APPLICATION NO.	FILING DATE	FIRST NAMED INVENTOR	ATTORNEY DOCKET NO.	CONFIRMATION NO.
10/797,452	03/10/2004	Sam Baghdadi	2004P03672US	4438

**Advisory Action
Before the Filing of an Appeal Brief**

LABYRINTH GLAND CONSTRUCTION

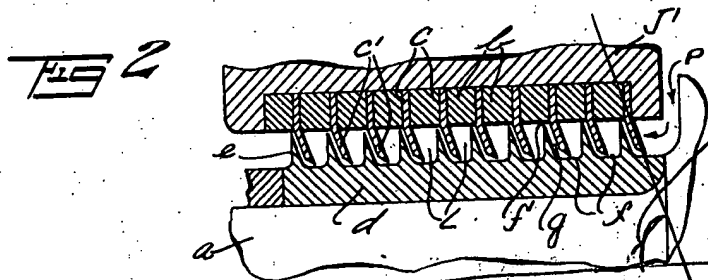
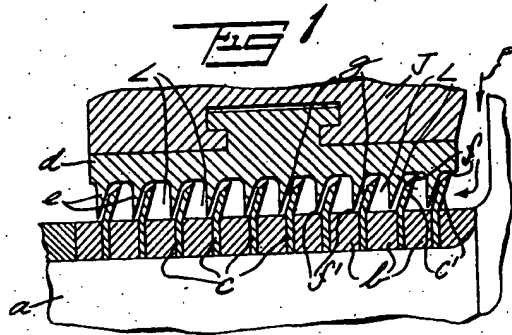
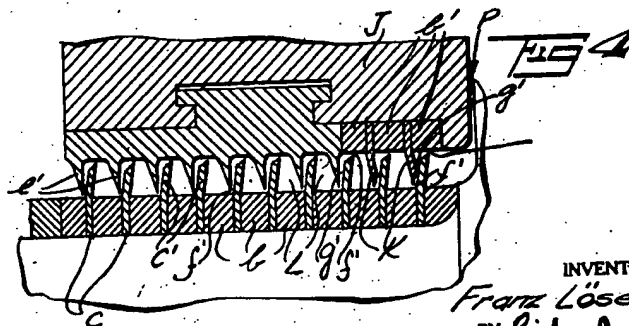
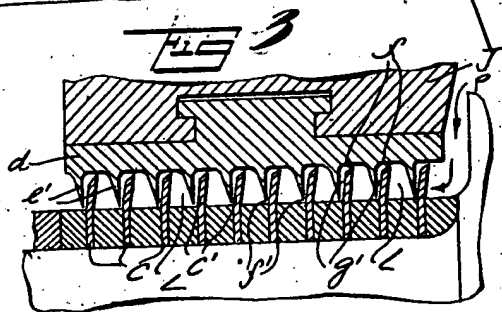
Continuation of 11. does NOT place the application in condition for allowance because: Applicants' argument against Groos, Bunker and Losel is not persuasive because as stated in the rejection Gross teaches blades on stationary and rotary bodies, Bunker teaches that the blades on the rotary body are at an acute angle relative to the rotational axis and Losel teaches that the blades on the stationary body are at an acute angle relative to the rotational axis (see attached figure).

Acute Angle

Rotational Axis
